Victoria Point Manchester

Empiric Student Property PLC
NMA - Blocks 2-4 Amendments

16/01/2026
Issue 03

Non-Material Amendment

Blocks 2 & 3 Overview

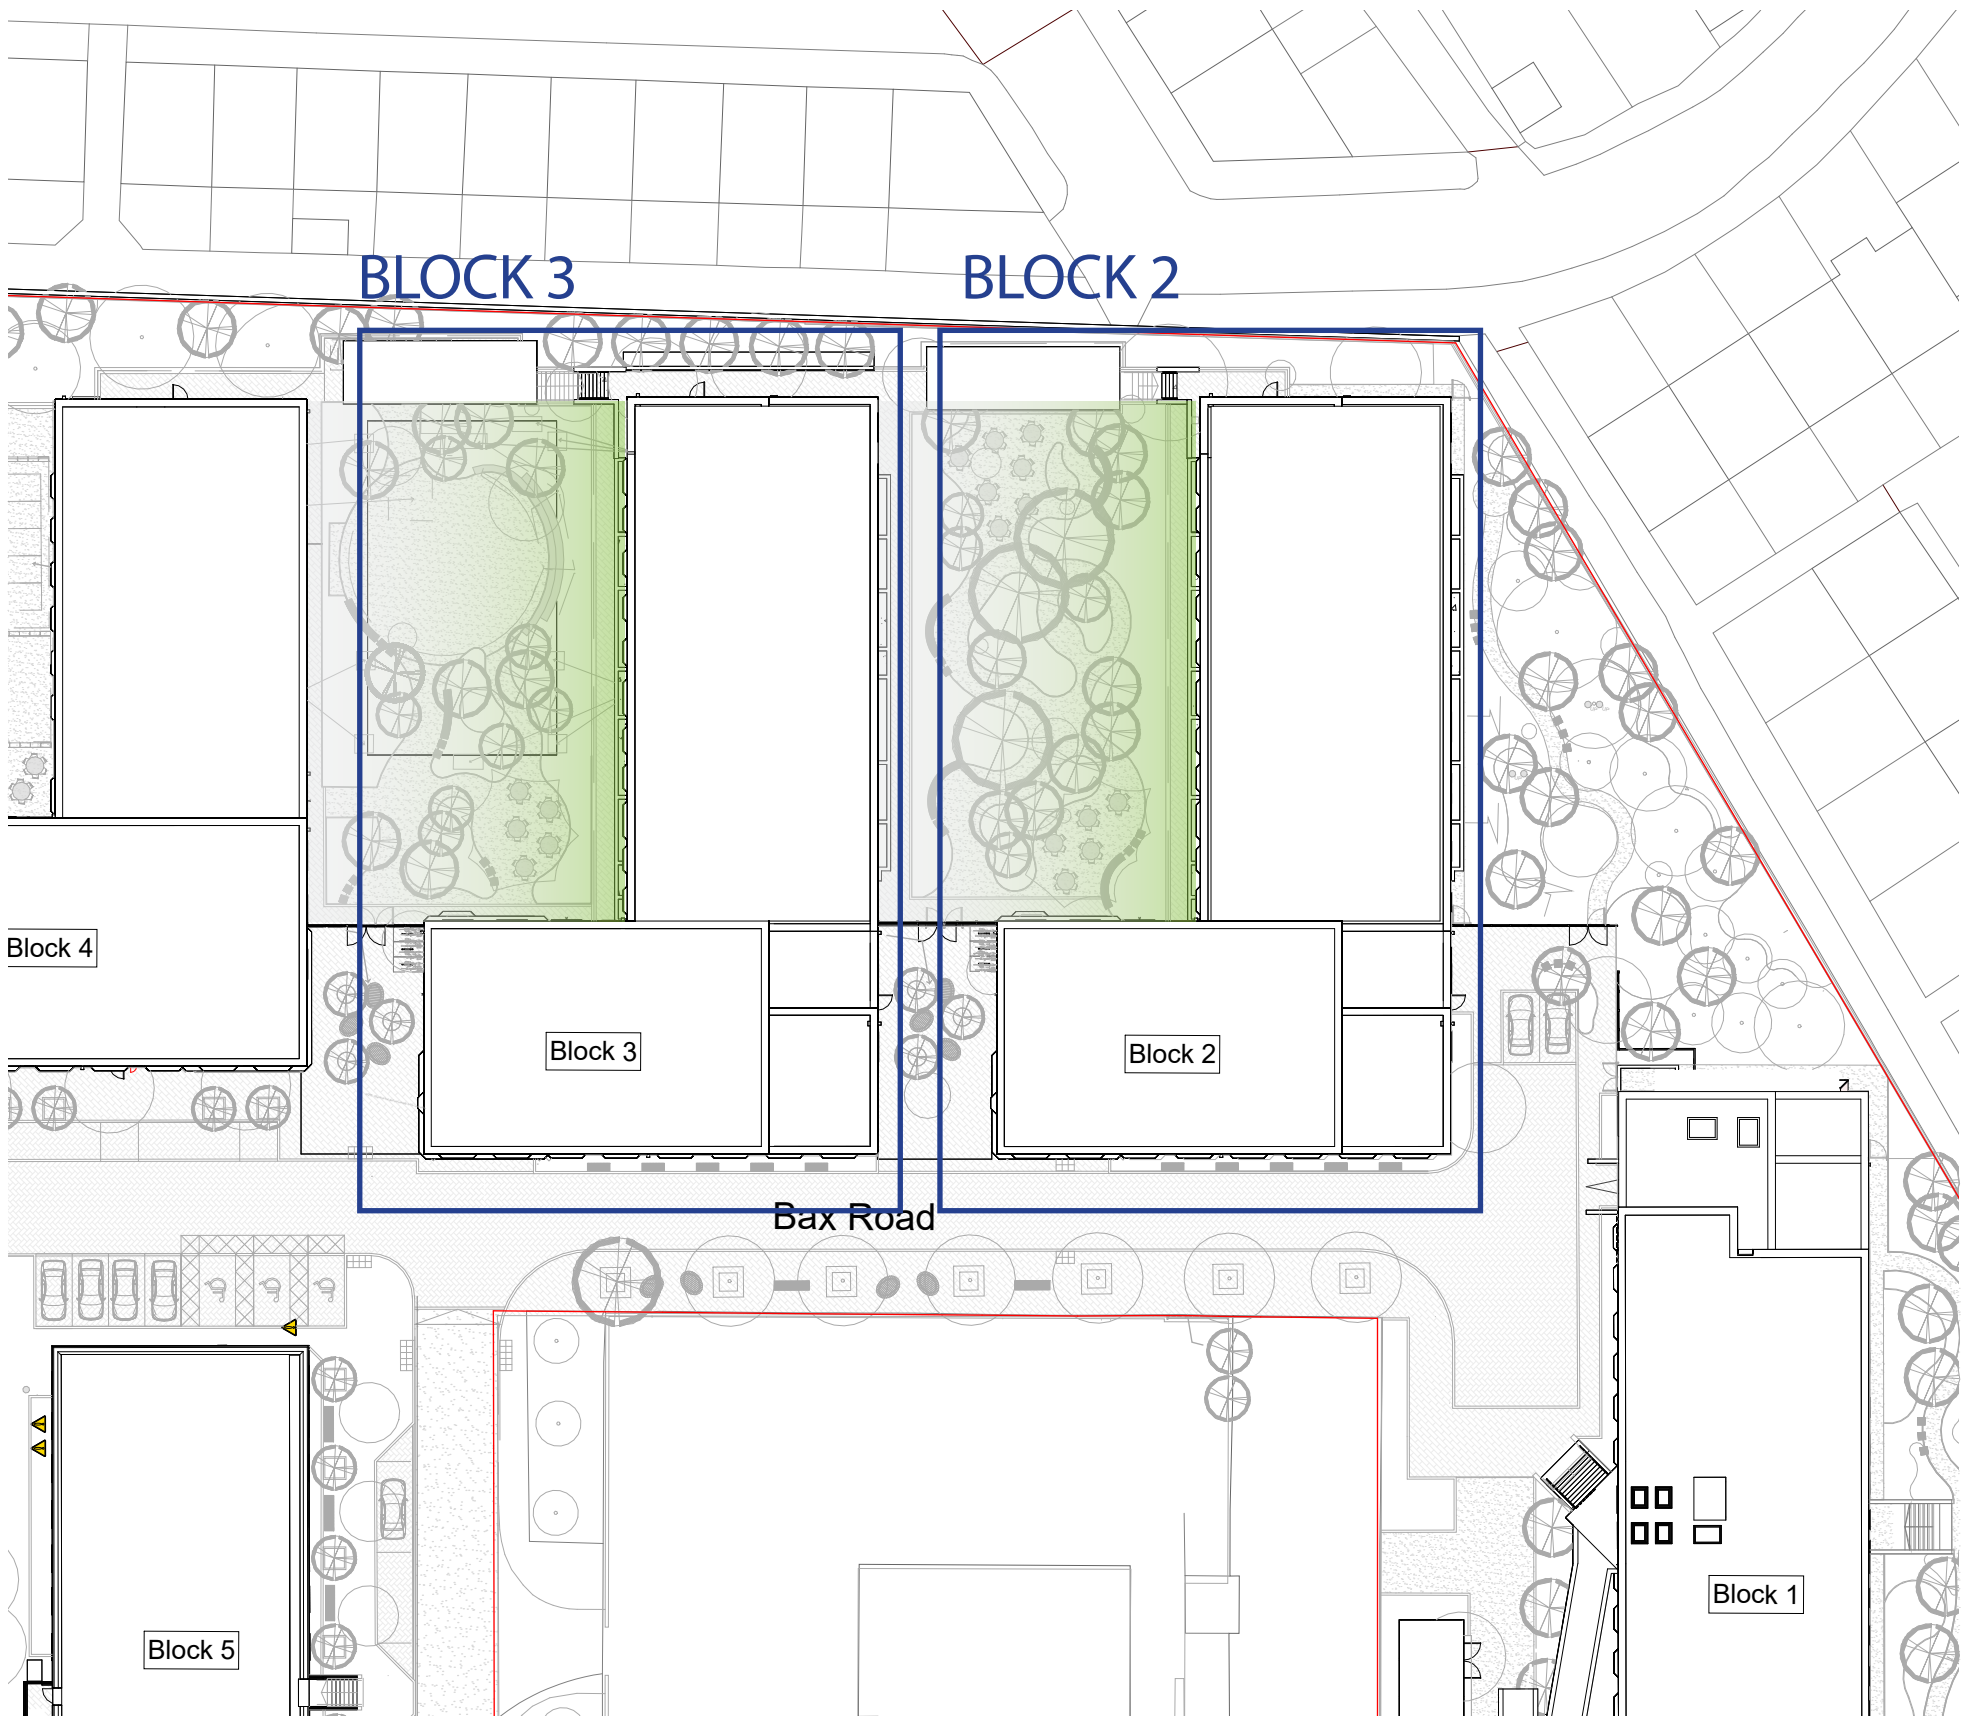
It is proposed that the levels within the courtyards and adjacent to Blocks 2 and 3 are to be regraded to the building edge. This approach will allow for a more usable and legible courtyard layout.

Below are some existing photos to show the existing condition, and in red the proposed adjustments.

Block 2 Summary

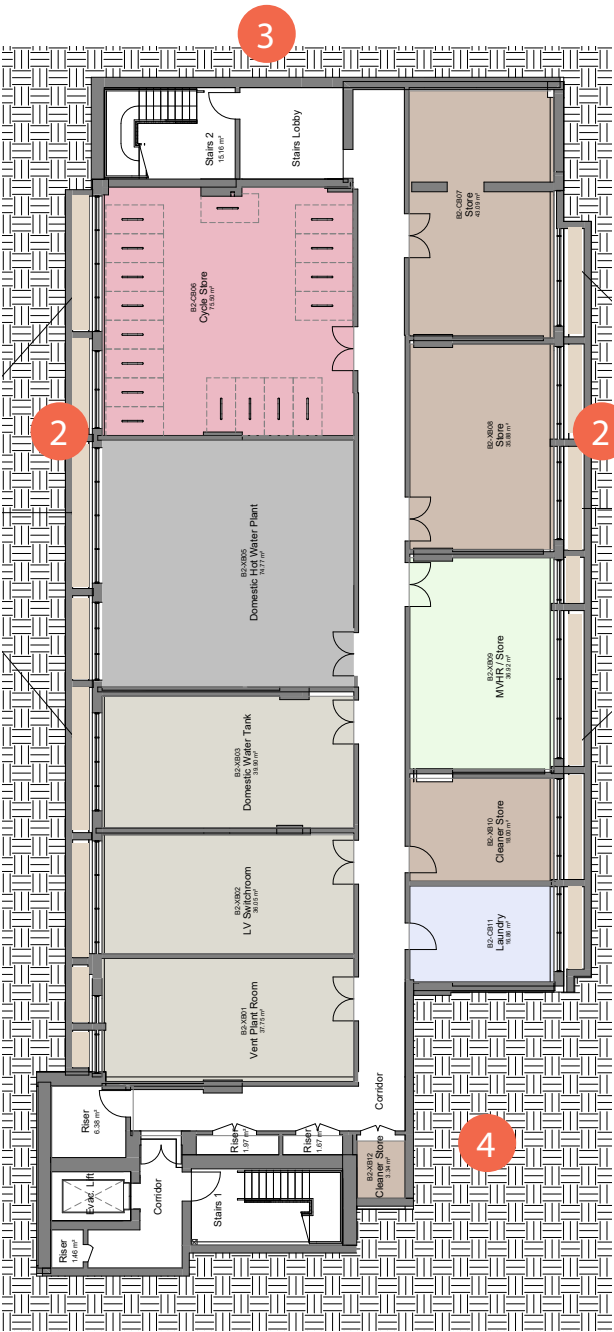
- These diagrams note the various changes that are proposed to Block 2. These include:
1. Regrading of the site landscaping around the perimeter of Blocks 2 & 3
 2. The introduction of smoke vents to the perimeter of the retained blocks
 3. The reconfiguration of access to the basement which includes the removal of basement access to the rear of the blocks
 4. An overall reduction in the basement size

Block 3 Summary

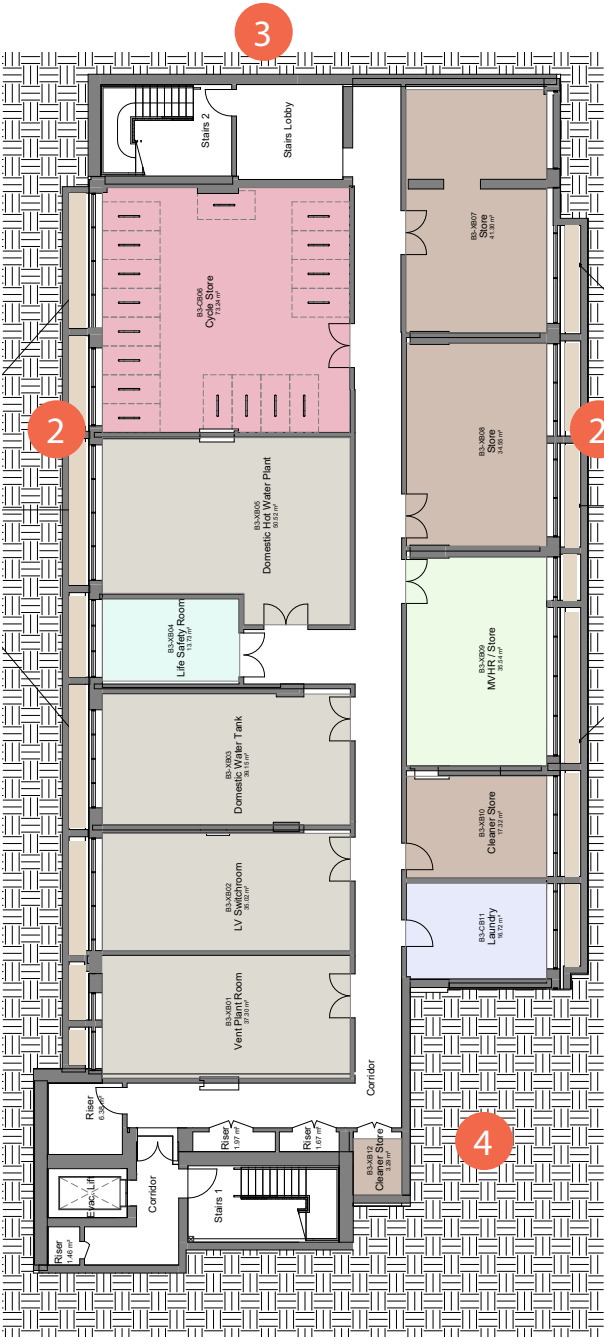
These diagrams note the various changes that are proposed to Block 3. These include:

1. Regrading of the site landscaping around the perimeter of Blocks 2 & 3
2. The introduction of smoke vents to the perimeter of the retained blocks
3. The reconfiguration of access to the basement which includes the removal of basement access to the rear of the blocks
4. An overall reduction in the basement size

NMA Section through Blocks 2 & 3

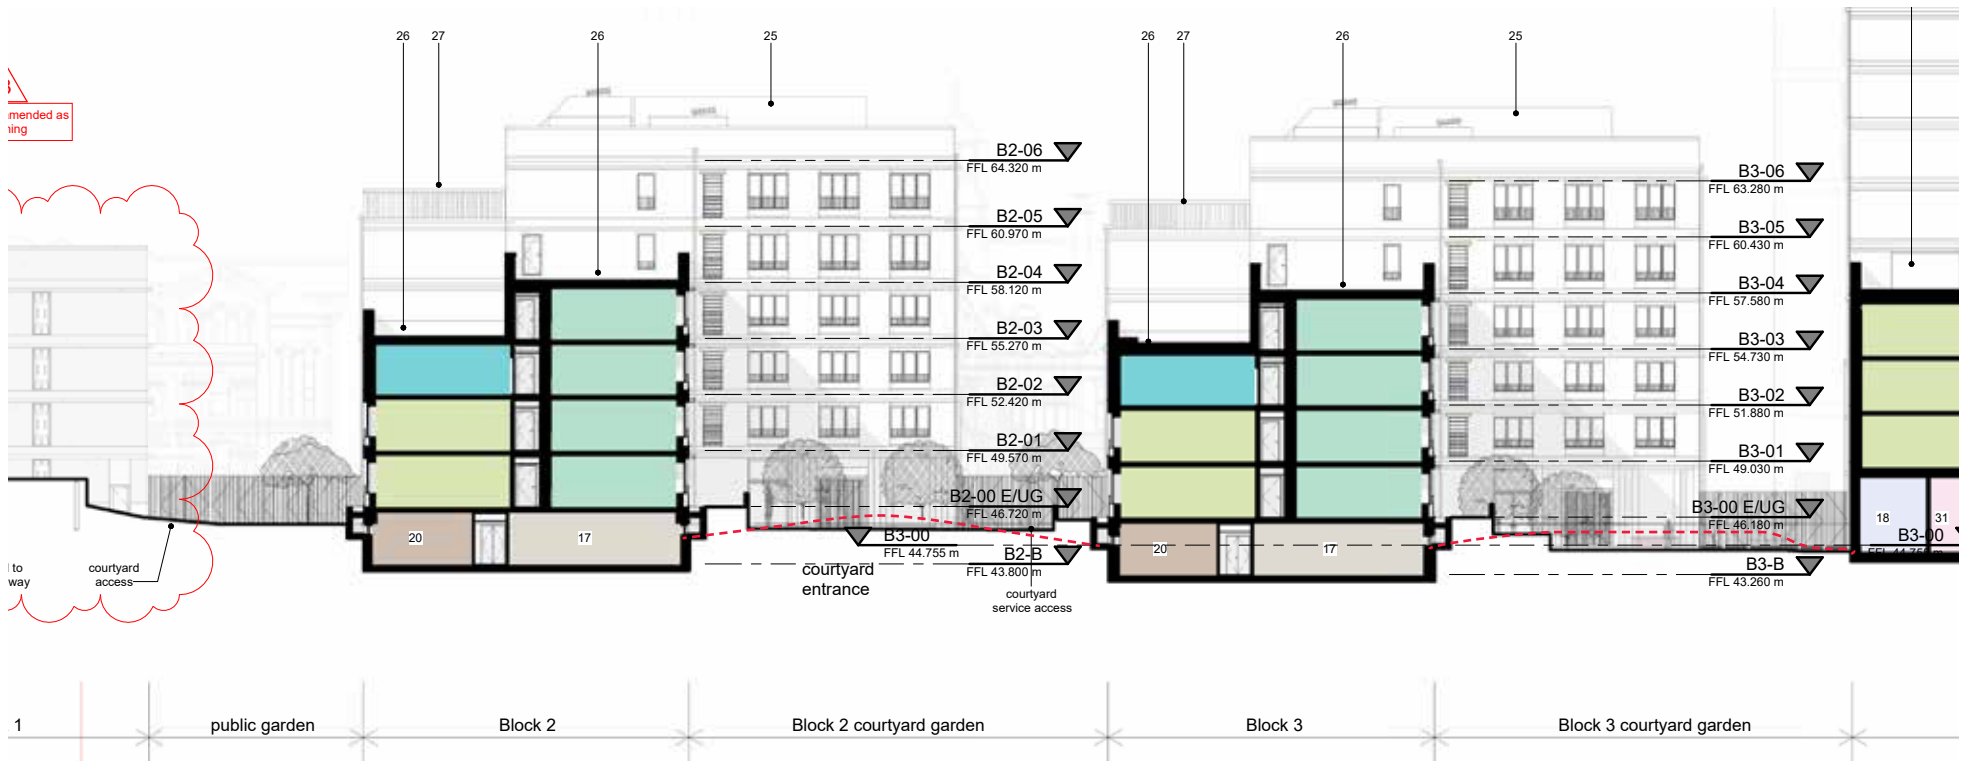
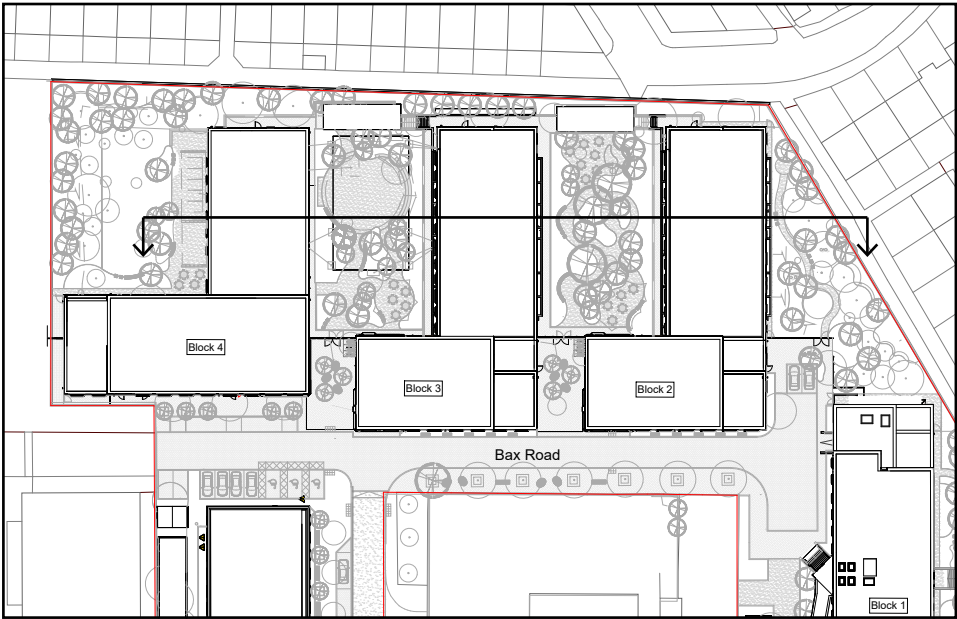
In section, the existing landscape can be understood. The levels dip from a raised centre to allow ventilation to the existing basements.

The proposed strategy is to regrade the landscape to create a more usable and legible courtyard. This will see the landscape step up to the ground floor level of the existing blocks to create tiered planting to the courtyard edges. This will require the basement to be ventilated via 'swan-neck' vents that terminate at ground floor level.

NMA Section through Blocks 2 & 3

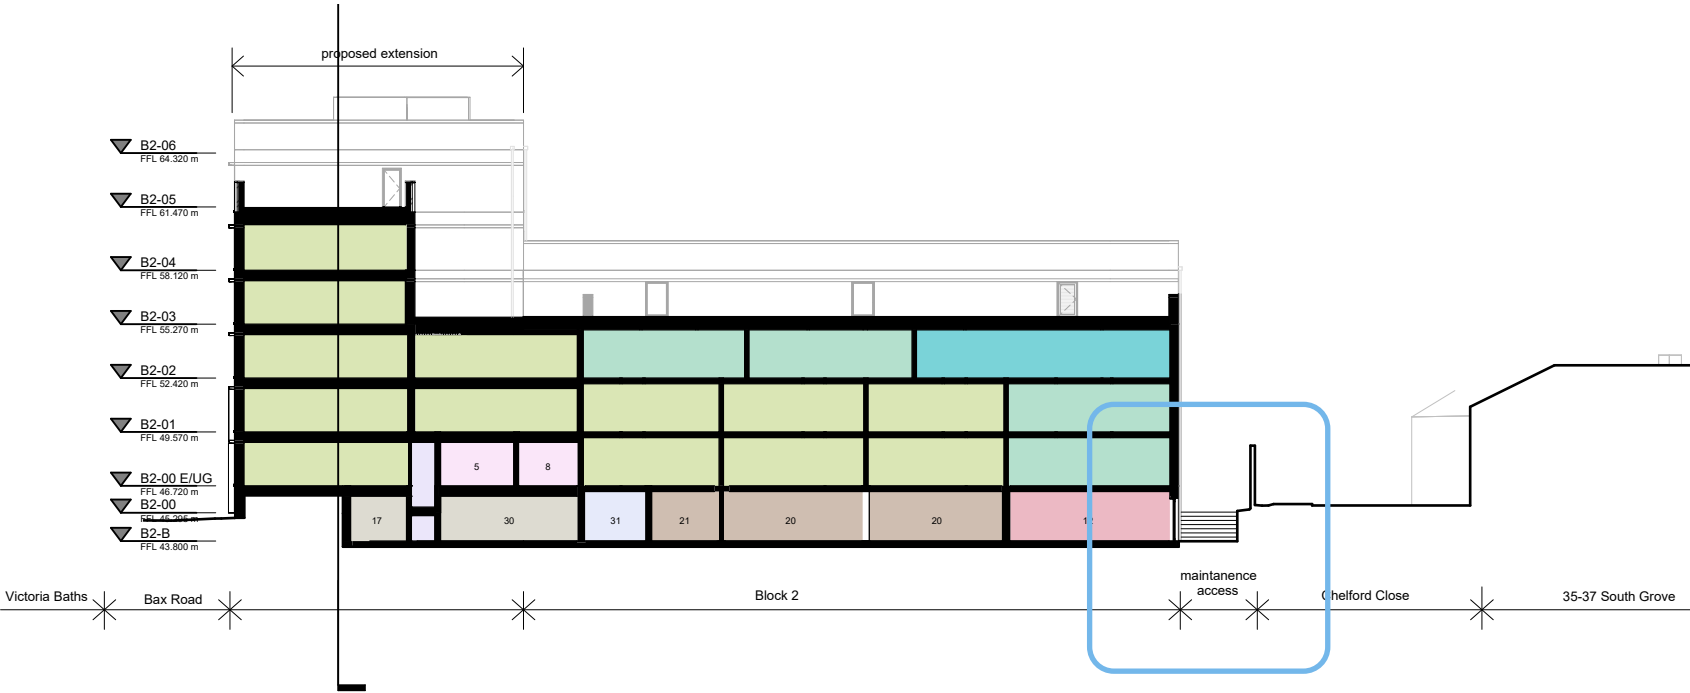
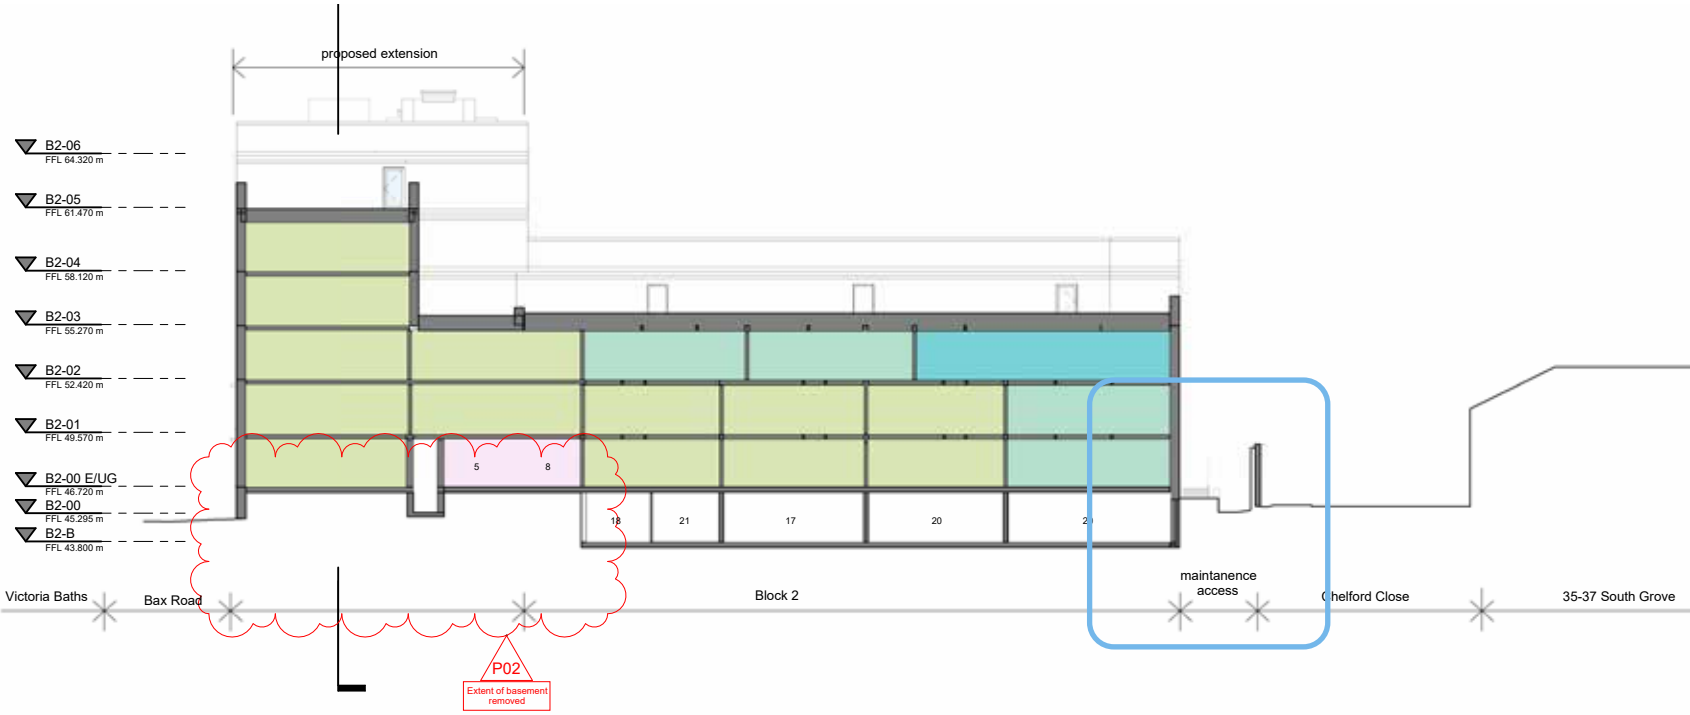
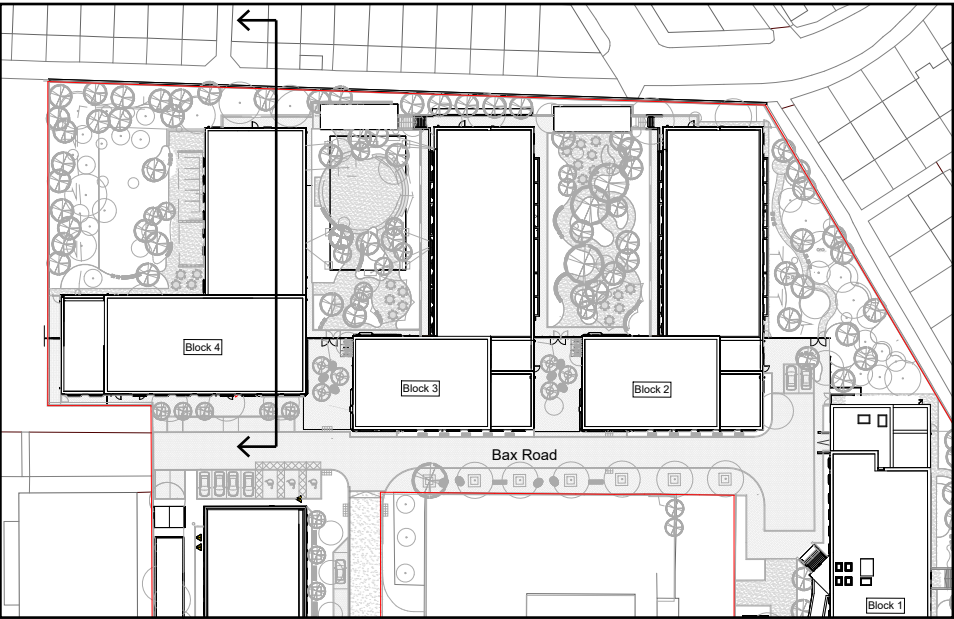
At planning approval, the existing condition to the rear of the site (highlighted) included a stepped access to the rear of the existing block.

The NMA application seeks to alter this to remove the basement access and instead allow for an emergency egress from the proposed stair at ground level. This will raise the ground level to the rear of the site, however the existing level adjacent the boundary wall will not change.
